**RE: Eubank Animal Hospital Expansion
1601 Eubank Blvd NE
Grading and Drainage Plan
Engineer's Stamp Date: 11/15/19
Hydrology File: J20D032**

Based upon the information provided in your submittal received 12/24/2019, the Grading & Drainage Plan is approved for Building Permit.

A1 GRADING & DRAINAGE PLAN

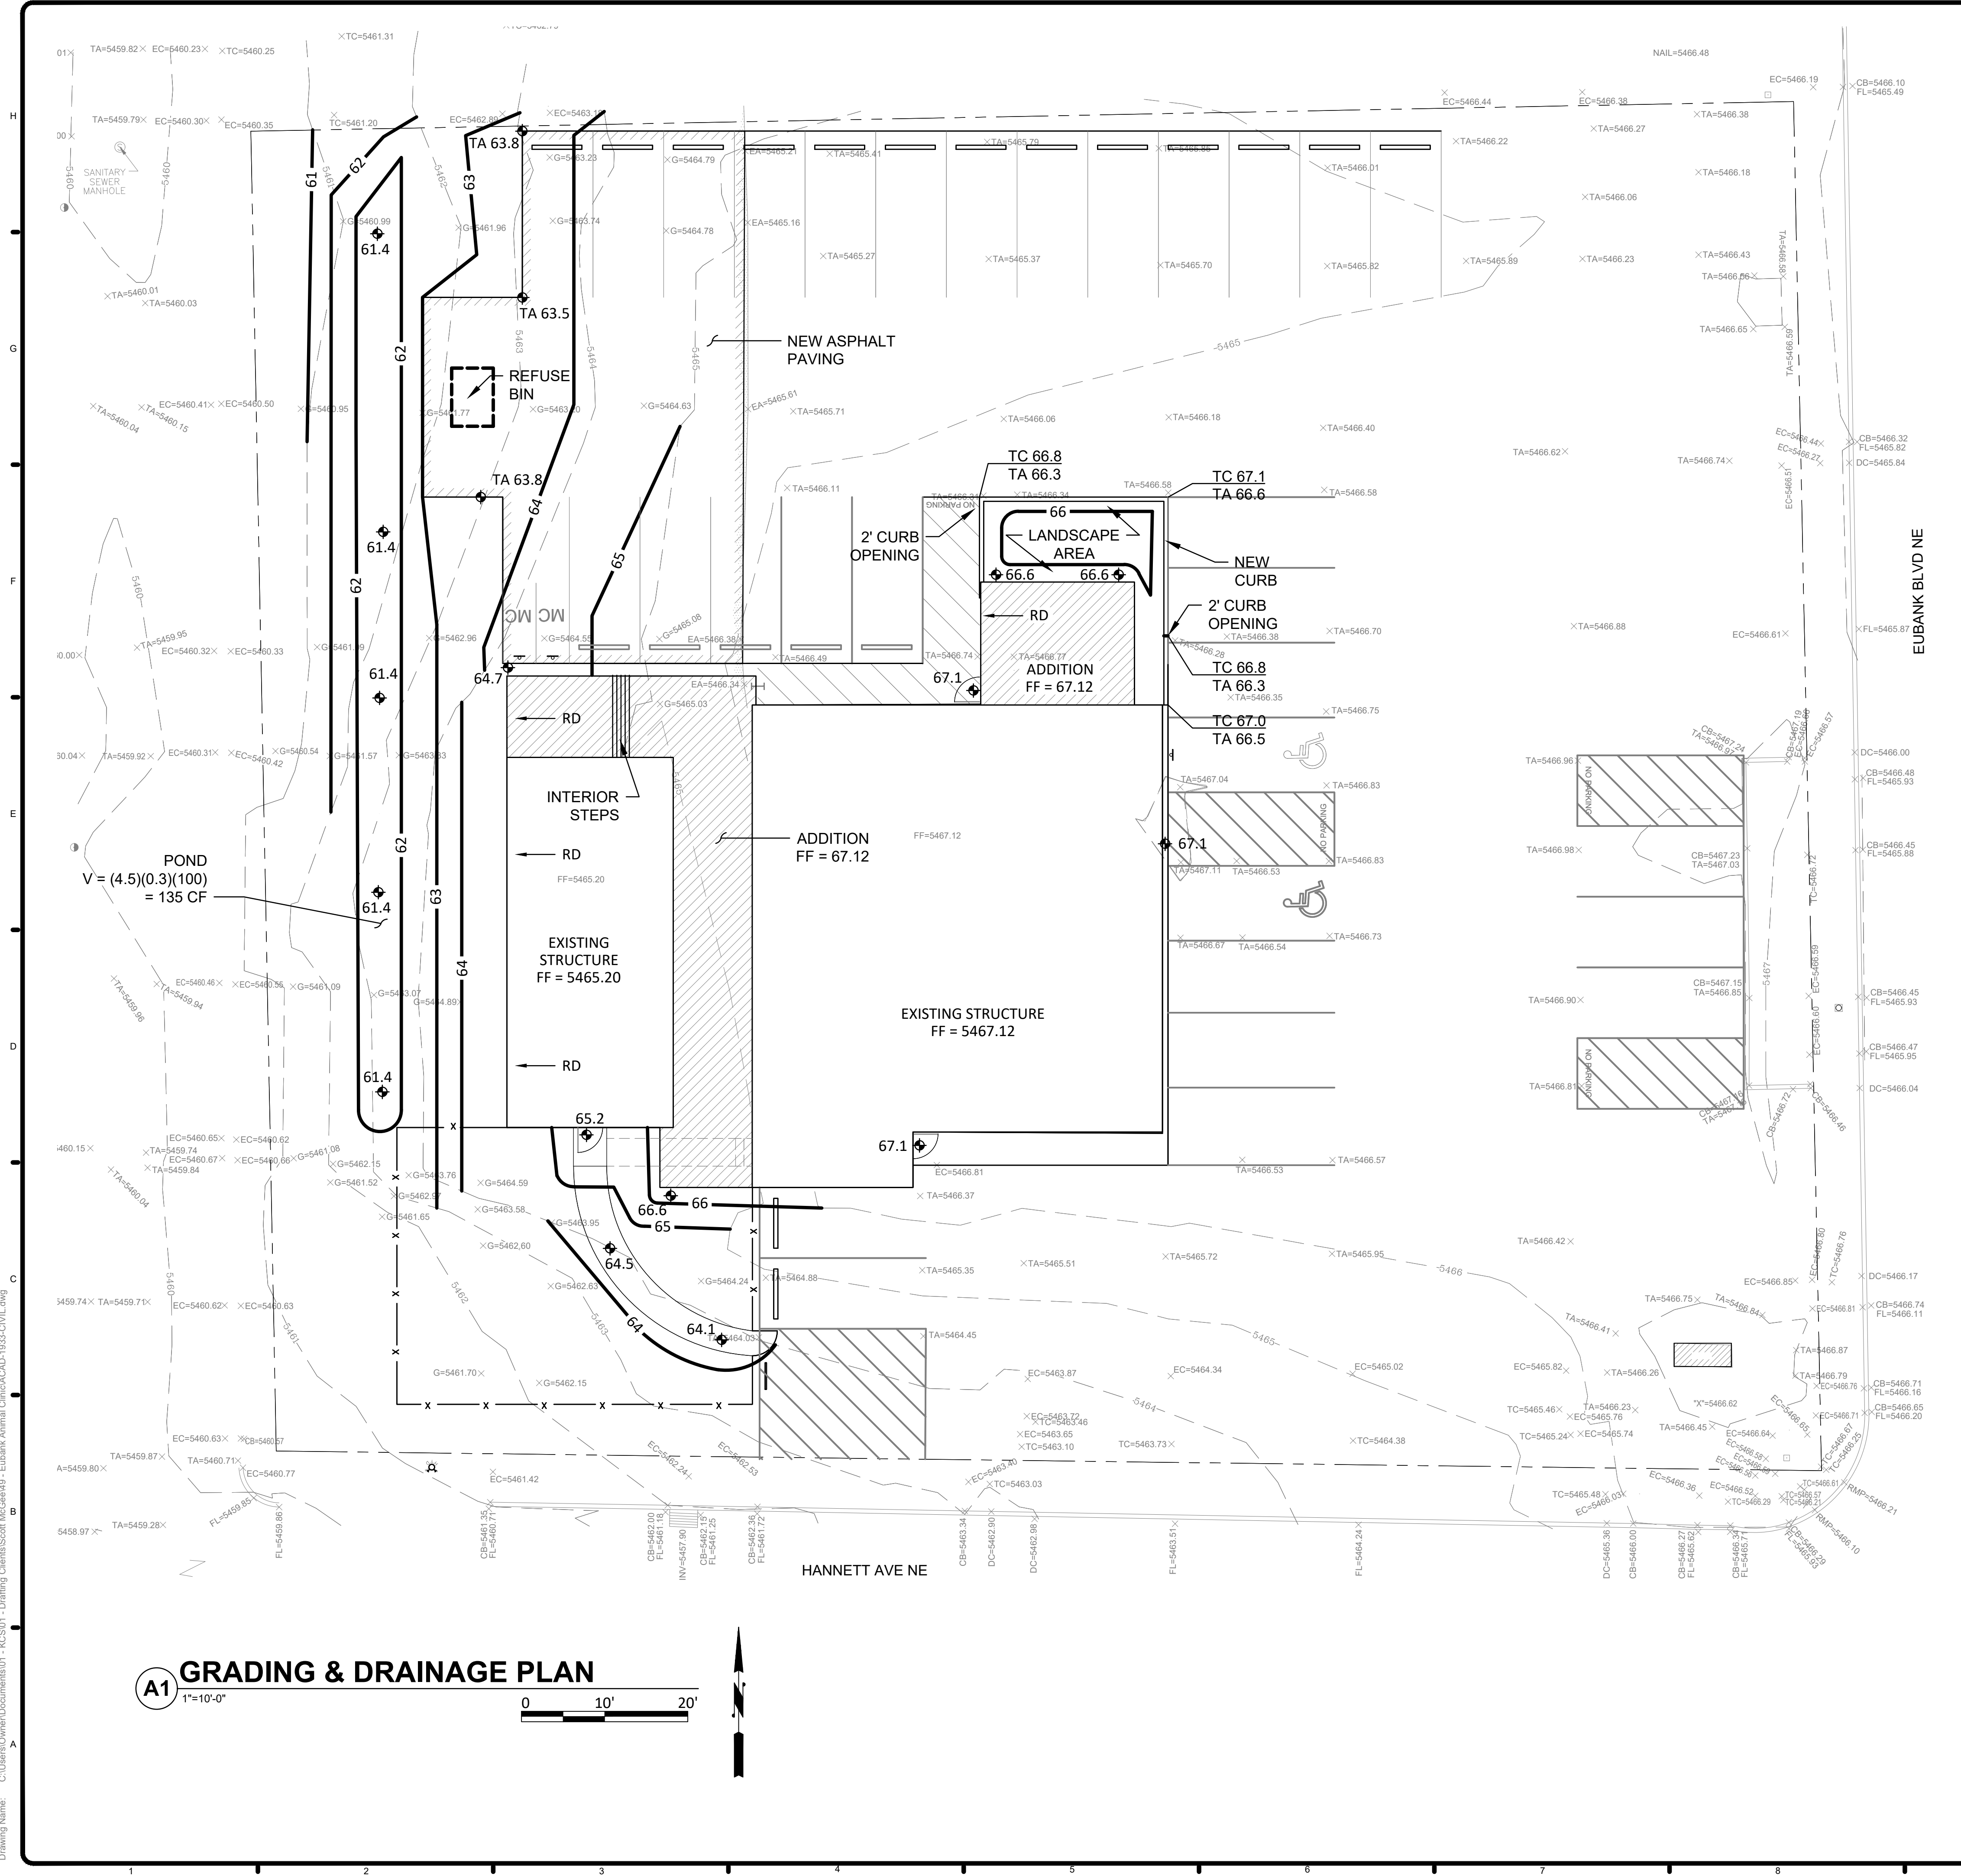
Please attach a copy of this approved plan in the construction sets for Building Permit processing along with a copy of this letter. Prior to approval in support of Permanent Release of Occupancy by Hydrology, Engineer Certification per the DPM checklist will be required.

As a reminder, if the project total area of disturbance (including the staging area and any work within the adjacent Right-of-Way) is 1 acre or more, then an Erosion and Sediment Control (ESC) Plan and Owner's certified Notice of Intent (NOI) is required to be submitted to the Stormwater Quality Engineer (Dough Hughes, PE, jhughes@cabq.gov, 924-3420) 14 days prior to any earth disturbance.

Also as a reminder, please provide a Drainage Covenant for the proposed stormwater quality pond per Chapter 17 of the DPM prior to Permanent Release of Occupancy. Please submit this on the 4th floor of Plaza de Sol. A \$25 fee will be required.
